W3F1-2015-0075

SUBJECT: Update to Responses to Request for Additional Information Regarding
Adoption of National Fire Protection Association Standard NFPA 805 License
Amendment Request (LAR)
Waterford Steam Electric Station, Unit 3 (Waterford 3)
Docket No. 50-382
License No. NPF-38

Updated FPE RAI 10 Response

SKETCH (Not to Scale)
RAB -4' Elevation

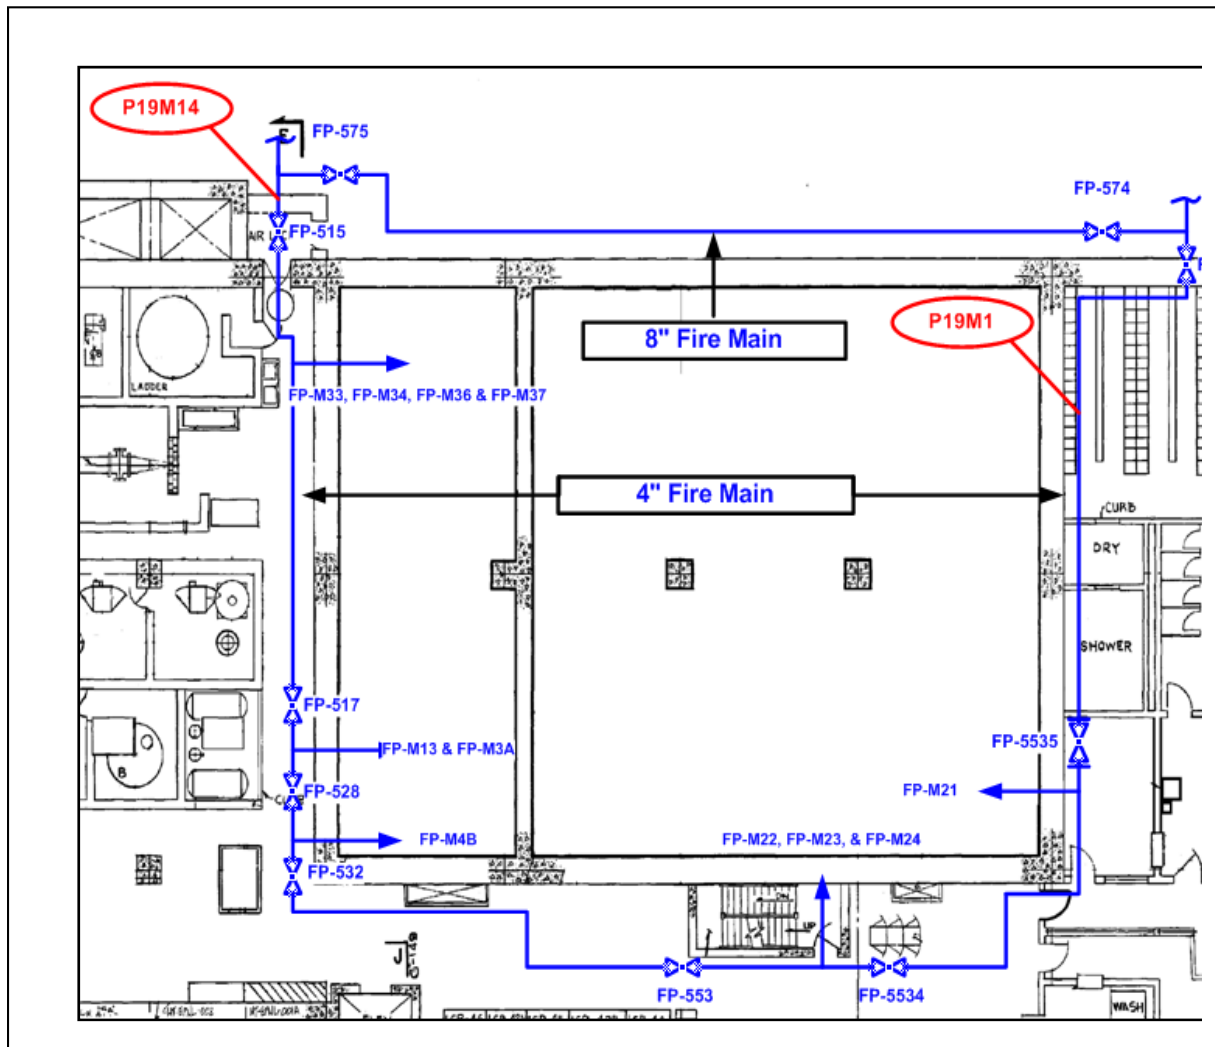
Attachment L, Approval Request 6 -A deviation from NFPA 805 Section 3.5.1 is requested for several plant areas where the fire water supply demand is not met with the least demanding portion of the main loop out of service. Please justify this deviation to include a discussion of the following:

- a. *The location of this 4" loop section.*
- b. *The procedures in place to mitigate.*
- c. *The capacity of the three sprinkler systems given the least demanding portion of the main loop is out of service.*

a. ***Location of this 4" loop section:***

An 8 inch diameter fire main is routed through the Reactor Auxiliary Building (RAB) and connects to the outside 10 inch diameter underground fire main loop on both the east and west sides of the RAB. This 8 inch fire main traverses east/west near the south wall of Fire Area RAB 32 (RAB -4' Elevation). The 4 inch fire main loop, addressed in Attachment L Approval Request 6, connects to the above described 8 inch fire main in Fire Area RAB 32 (approximately 3 feet west of column line 10AZ and approximately 2'-8" north of column line L). The 4 inch loop then traverses south into Fire Area RAB 30, then west and north in Fire Area RAB 31 around the Condensate Storage and Refueling Water Pools before re-entering Fire Area RAB 32 (RAB -4'Elevation) over fire door D-161 (along column line L between column lines 5A and 6A). The 4 inch loop then connects back into the 8 inch fire main loop in RAB 32 (approximately 7'-2" west of column line 6A and approximately 11'-6" north of column line L). This 4 inch loop is approximately 300 linear feet of pipe in length and runs in the overhead areas of the -4 foot elevation in the RAB. See Sketch below for general routing of the 8 and 4 inch fire mains discussed above.
